MECKLENBURG COUNTY
Public Health

Re: Application for improvement permit for: 4 Bedroom House
Property Location: 5520 Brickstone Dr, Charlotte, NC 28227 (PID 109-313-03)
Health Department File Number: 9803B (App ID 9107)

SOIL/SITE EVALUATION
for ON-SITE WASTEWATER SYSTEM

Sketch of Soil Evaluation Locations

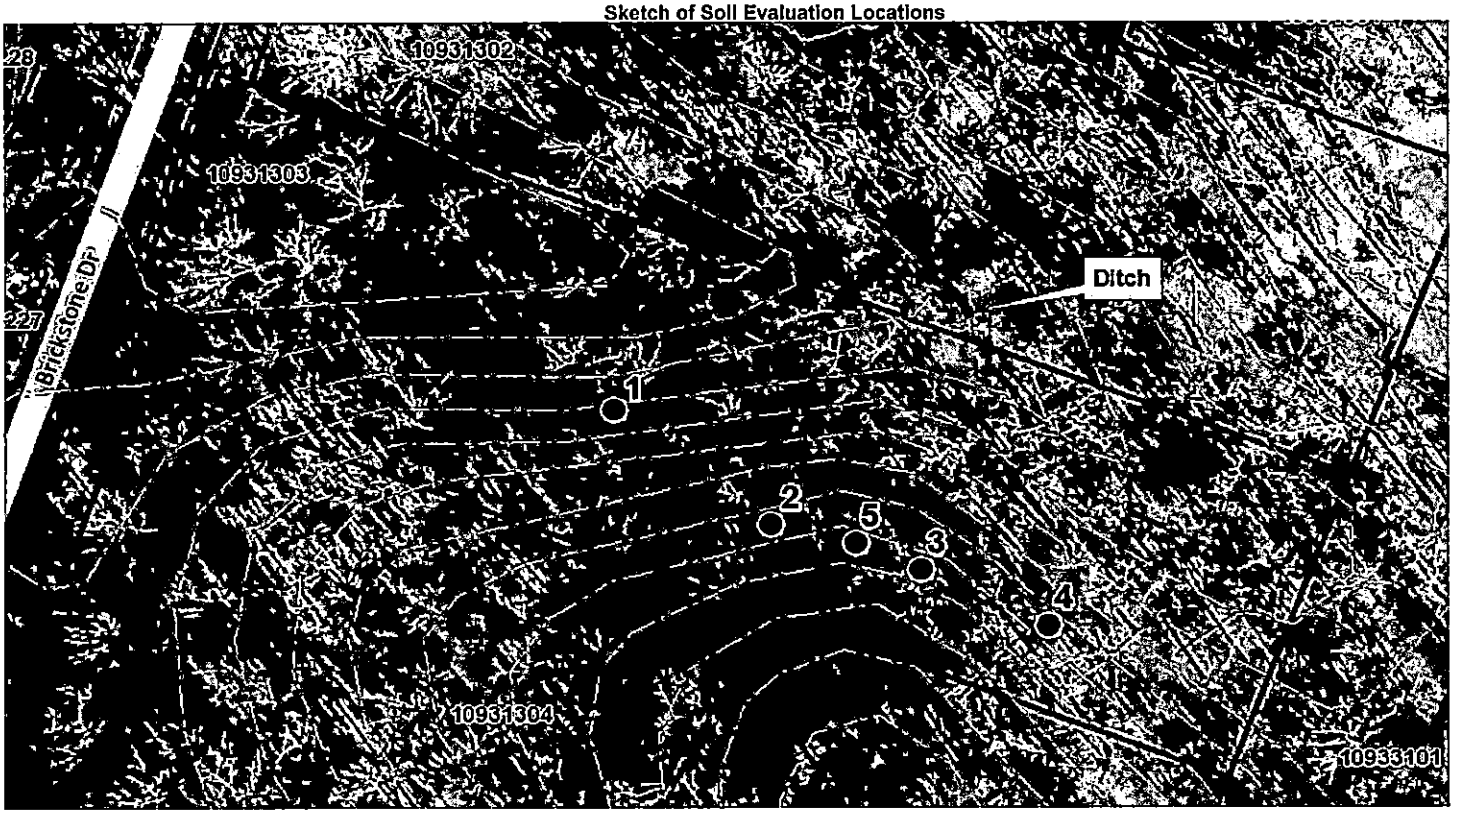
PROFILE #	.1940 Landscape Position/ Slope%	Horizon Depth (IN.)	SOIL MORPHOLOGY .1941 .1941 Structure/ Texture	.1941 Consistence Mineralogy	b PROFILE FACTORS .1942 Soil Wetness/ Color	.1943 Soil Depth (IN.)	.1956 Sapro Class	.1944 Restr Horiz	General Comments	Profile Class & LTAR	Maximum Trench Bottom Depth for 3' Wide Conventional Trench
Pit #1	HS 10%	0 - 8	gr SIL	SS SP FR SEXP	2 chroma at 15"	53	NA	NA		US	NA
		8 - 22	sbk SICL	SS SP FR SEXP							
		22 - 53	sbk C	S VP VFI EXP							
Pit #2	SS 12%	0 - 8	gr SIL	SS SP FR SEXP	>44	20	NA	NA	Clay and saprolite inclusions 20 - 44"	US	NA
		8 - 20	sbk SICL	SS SP FR SEXP							
		20 - 44	Rock								
Pit #3	SS 10%	0 - 4	gr L	SS SP FR SEXP	>38"	38	NA	NA		PS IV 0.25	22"
		4 - 24	sbk C	S P FR SEXP							
		24 - 38	sbk CL	SS P FR SEXP							
		38	Rock								
Pit #4	LS 20%	0 - 6	gr L	SS SP FR SEXP	>37"	37	NA	NA	rock inclusions 24 - 37"	PS IV 0.25	18"
		6 - 24	sbk C	S P FR SEXP

24 - 37	sbk CL	SS P FR SEXP							
		37	Rock								
Pit #5	SS 14%	0 - 4	gr L	SS SP FR SEXP	>42"	36	PS	NA		PS IV 0.25	22"
		4 - 27	sbk C	S P FR SEXP							
		27 - 36	sbk CL	SS SP FR SEXP							
		36 - 42	mass SIL Sap	SS SP FR SEXP							
		42	Rock

Description	Initial System	Repair System
Available Space (.1945)	US	US
System Type(s)	NA	NA
Site LTAR (gpd/sq ft)	0.25	0.25

Other Factors (.1946):
Soil Evaluation By: Jacob Presley, REHS, LSS
Others Present:
Site Classification (.1948): Unsuitable
Site Evaluation By: Jacob Presley, REHS, LSS
Others Present:
